11 - 2009

1/8" CUT-OUT TOOL

SERVICE CHANGE

Installation of 1/8" Bit (Item No. A04 & A05)

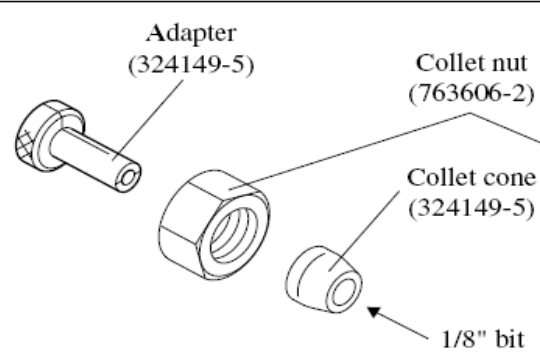
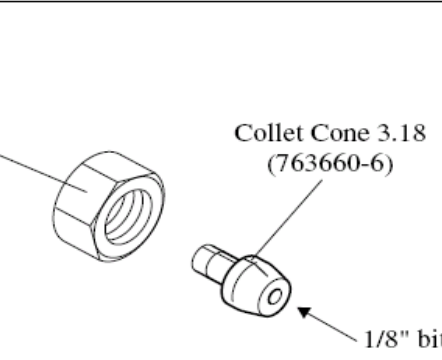
► Current	► New
 Adapter (324149-5) Collet nut (763606-2) Collet cone (324149-5) 1/8" bit	 Collet Cone 3.18 (763660-6) 1/8" bit
